Re: Riverkeeper, Inc.'s Comments on the U.S. Nuclear Regulatory Commission's Generic Environmental Impact Statement for License Renewal of Nuclear Plants, Supplement 38, Regarding Indian Point Nuclear Generating Unit Nos. 2 and 3, Draft Report for Comment, Docket Nos. 50-247 and 50-286

This report comments on the US NRC 'Generic Environmental Impact Statement for License Renewal of Nuclear Plants Supplement 38: Regarding Indian Point Nuclear Generating Unit Nos. 2 and 3: Draft Report for Comment' issued December 2008 (NUREG – 1437), Environmental Impacts of Cooling System. We are only concerned here with aquatic issues, and the impact of the plant's cooling system on fish and crustaceans in particular. The main impacts we look at in this document are entrainment, impingement and the effect of the thermal plume.

Figure 2: The standardised juvenile index for white catfish in the Hudson, showing a decreasing trend though time. The trend is significant ($a = -0.0136$, $b = 27.216$, $F = 14.0414$, $p = 0.0008$) (Seaby and Henderson, 2007)

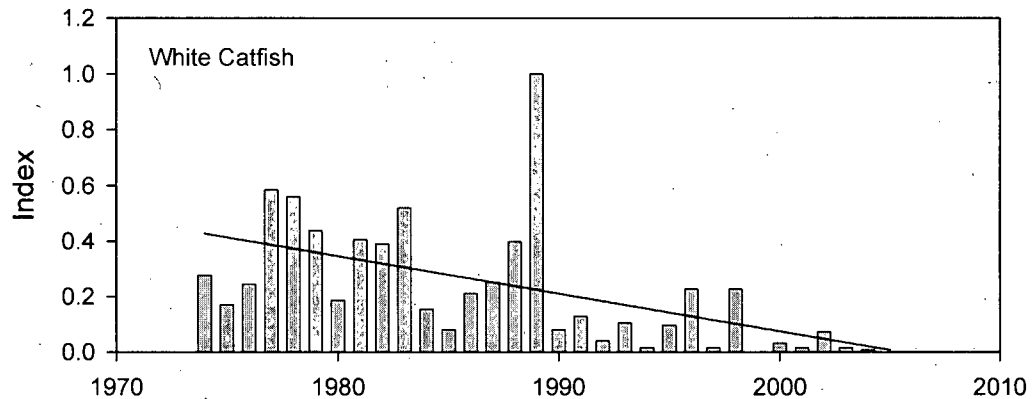
The Year Class Reports for the Hudson River Estuary Monitoring Program shows that, river-wide, juvenile white catfish have been in a steep decline in abundance since 1990 (Figure 2).

It is therefore unsurprising that in Table 4-4 (see Figure 1) the population line of evidence is for a 'Large' potential adverse impact. The trend shown in Figure 2, which is statistically significant, certainly seems to correspond with the definition of Large given on page H-33, NUREG-1437, Vol 2:

Figure 3: The standardised juvenile index for weakfish in the Hudson showing a decreasing trend though time. The trend is significant ($a = -0.0155$, $b = 31.0218$, $F = 7.0811$, $p = 0.0134$) (Seaby and Henderson, 2007)

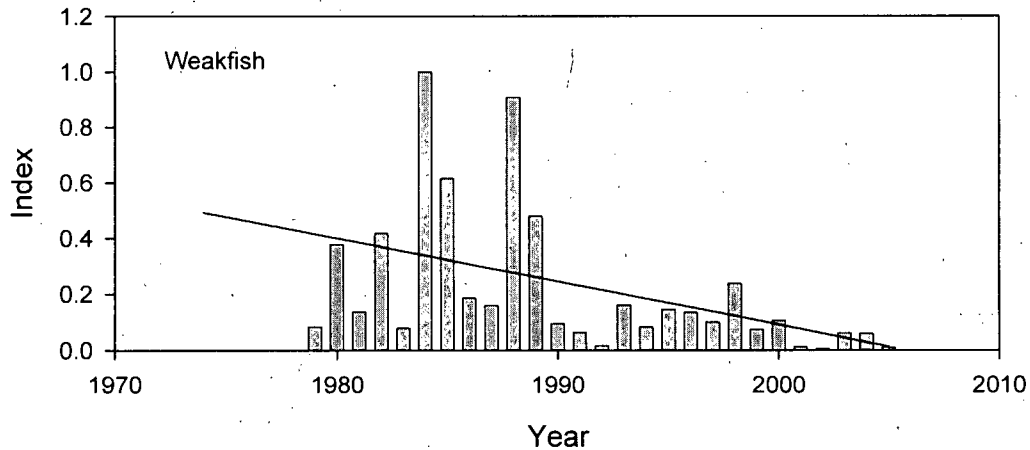
Like white catfish, weakfish have also shown river-wide a steep decline in abundance since 1990 (Figure 3). However, unlike white catfish, for this species Table 4-4 classifies the population line of evidence as 'Small'.

Figure 5: The standardized juvenile index for rainbow smelt in the Hudson.

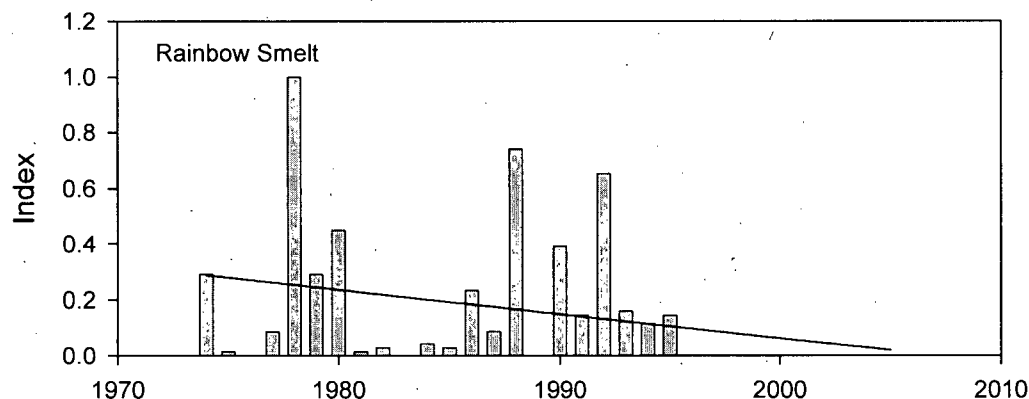
Juvenile rainbow smelt have disappeared from the survey since the mid 1990s (Figure 5), and it is therefore unsurprising that Table 4-4 assesses the population line of evidence as 'Large'. However, the impact of Indian Point 2 and 3 is assessed as moderate because the strength of connection is assessed as 'Medium'.

Figure 6: The standardised juvenile index for tomcod in the Hudson showing a decreasing trend though time. (Seaby and Henderson, 2007)

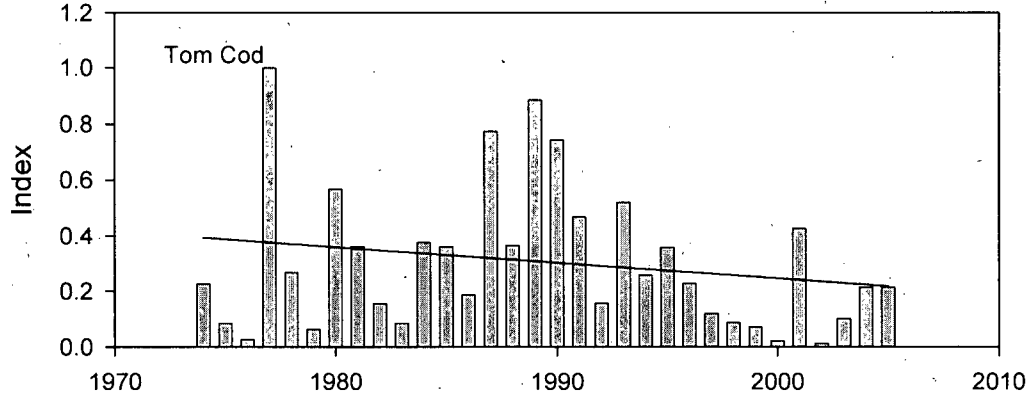
Examination of Table I-32 (Figure 4) shows that a number of the RIS species have a prey score for impingement and entrainment of 1, and thus are unlikely to score highly for the strength of connection. This feature of the scoring protocol is thus central to the final outcome. The Atlantic tomcod makes a telling further example. The tomcod population shows considerable year-to-year variation, but appears to be in long-term decline (Figure 6). The average standardised index from 1975 until 1995 is 0.158; in comparison the index for the last ten years of sampling (1996-2005) is only 0.0617. In the last 10 years, only 2001 produced a good recruitment, although there are signs of a recent slight improvement in tomcod numbers.

While the population line of evidence for a decline is large, the invertebrate prey of this species is primarily responsible for the low-to medium strength of connection and the final conclusion that the impact is small to moderate.
